NO. 206L-06-139

SUBJECT: AERONAUTICAL ACCESSORIES INC. FLAT CREW WINDOW P/N 206-202-103 AND 206-202-104, STC SH5773SW

ALERT SERVICE BULLETIN ASB No. AA-06066

SUBJECT: Flat Crew Window
P/N 206-202-103 / 206-202-104 / 206-202-001 / 206-202-002

FIGURE 1 – Identification

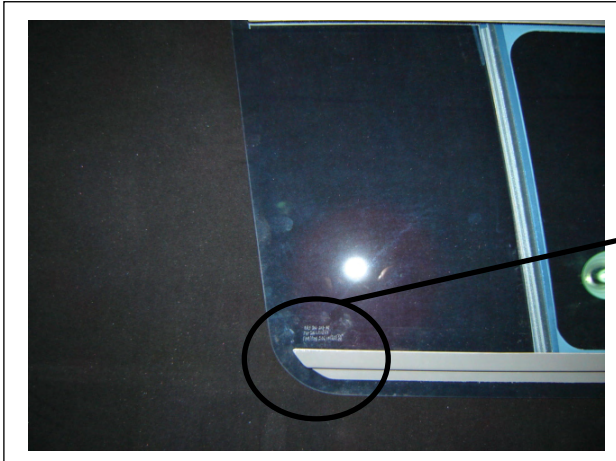
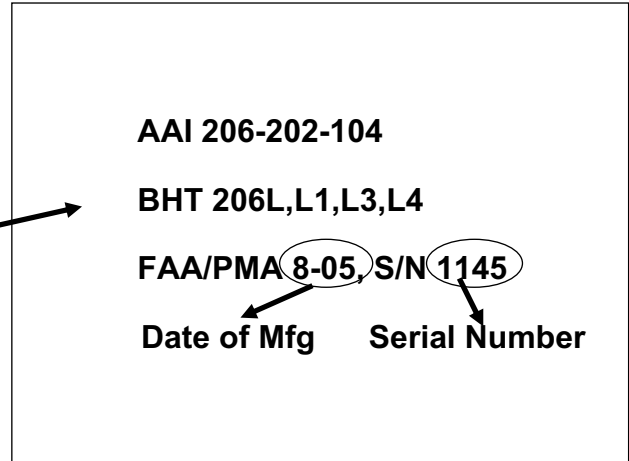
COMPLIANCE: Immediately upon receipt of this bulletin, determine by part number, serial number, and manufacture date (ref. Figure 1) if affected window(s) is (are) installed. Only those serial numbers listed are affected. A part with a serial number that is close to, or has a serial number prefix different from those listed is not affected by this bulletin. For installed windows, conduct Part I visual inspection within 8 hours; conduct Part II inspections within 24 hours. For uninstalled windows, accomplish Part I and Part II prior to installation on a helicopter.
NOTE: Part II Physical Inspection is a one-time inspection.

FIGURE 3 – Aft Pull Test Locations

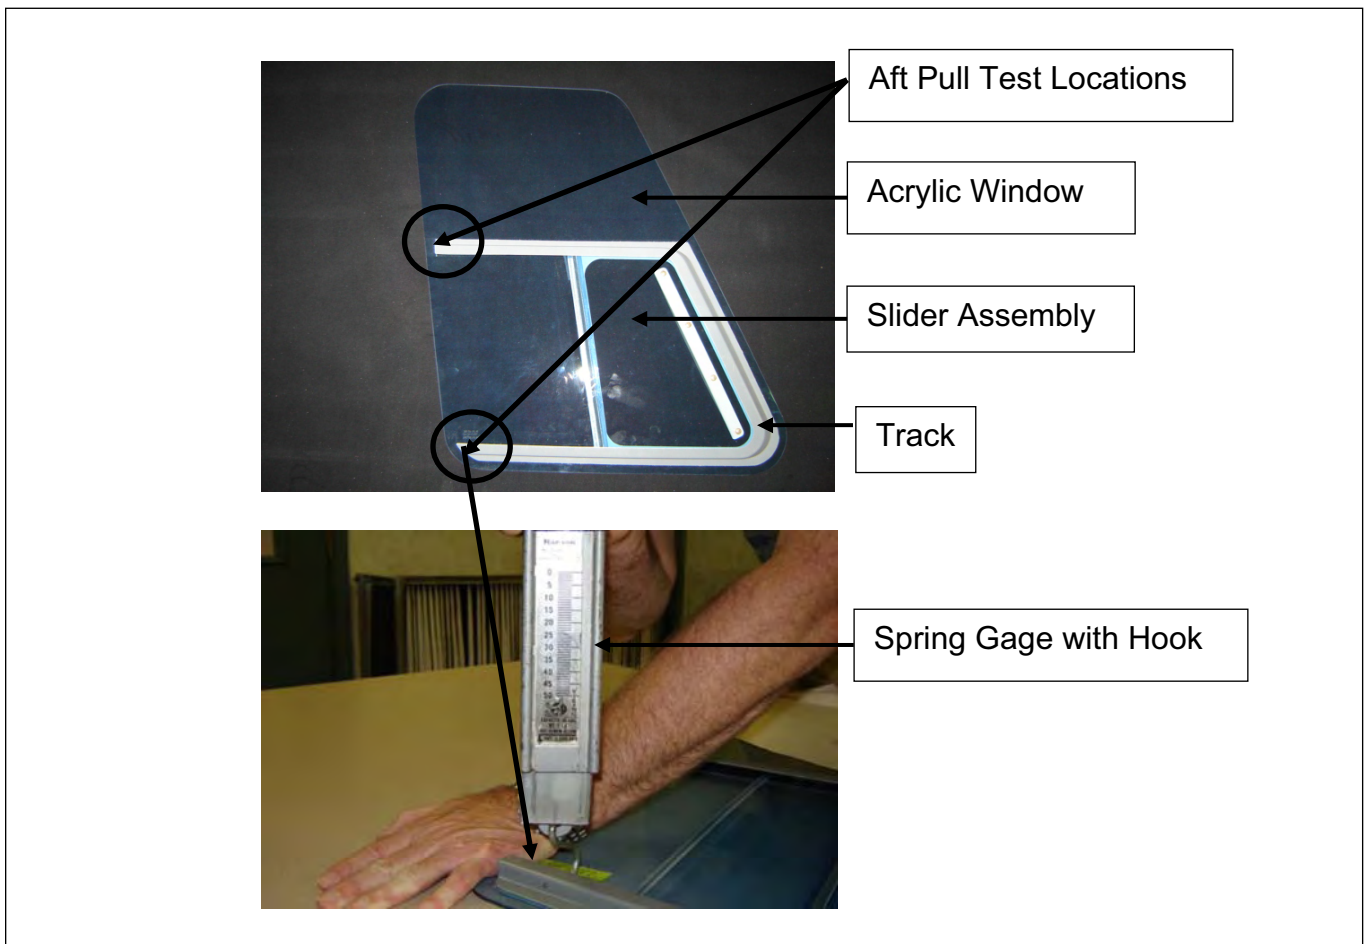
1. With the slider assembly in the full-closed (fwd) position from the exterior of the aircraft using the spring gage, insert the hook directly into the channel of the slider track at the aft end of the slider (ref. Figure 3). Pull outward on the slider track (away from the acrylic) until the gage reads 25 lbs. Visually inspect track frame of slider for any obvious signs that the frame is de-bonding from the acrylic.

2. Repeat step 1 at second track location indicated in Figure 3.
3. With the slider assembly in the full-closed (fwd) position, from the interior of the aircraft, apply manual outward pressure at the two locations indicated in Figure 4. Visually inspect slider track for any obvious signs that the track is de-bonding from the acrylic.

FIGURE 5 – Forward Pull Test Locations

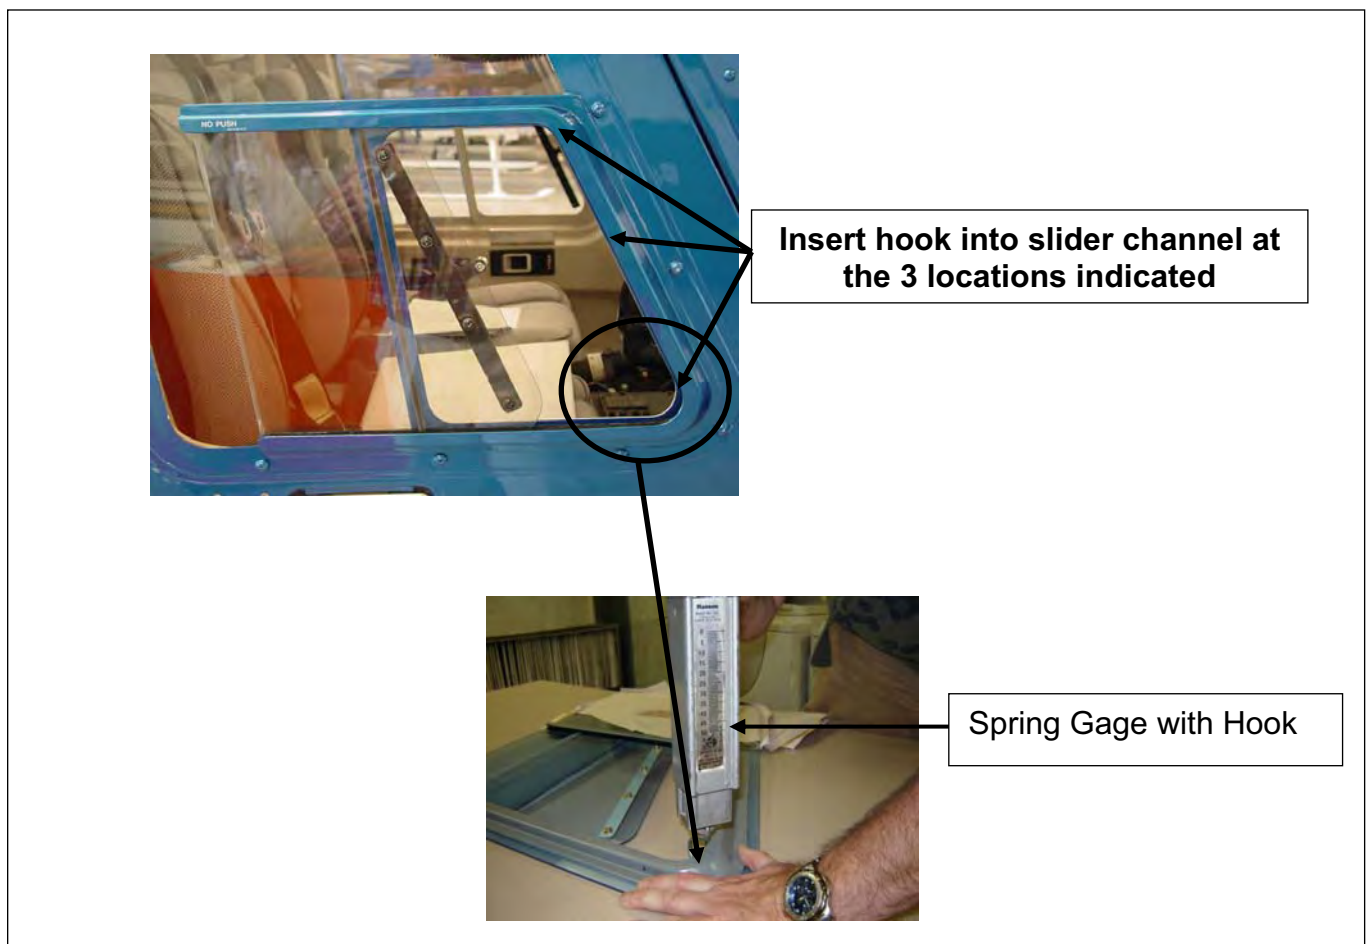
4. With the slider assembly in the full-open (aft) position, from the exterior of the aircraft, insert the spring hook directly into the channel of the slider track at the 3 locations indicated in Figure 5.

5. Using the spring gage, pull outward on the slider track (away from the acrylic) until the gage reads 25 lbs. Visually inspect the slider track for any obvious signs that the track is de-bonding from the acrylic.
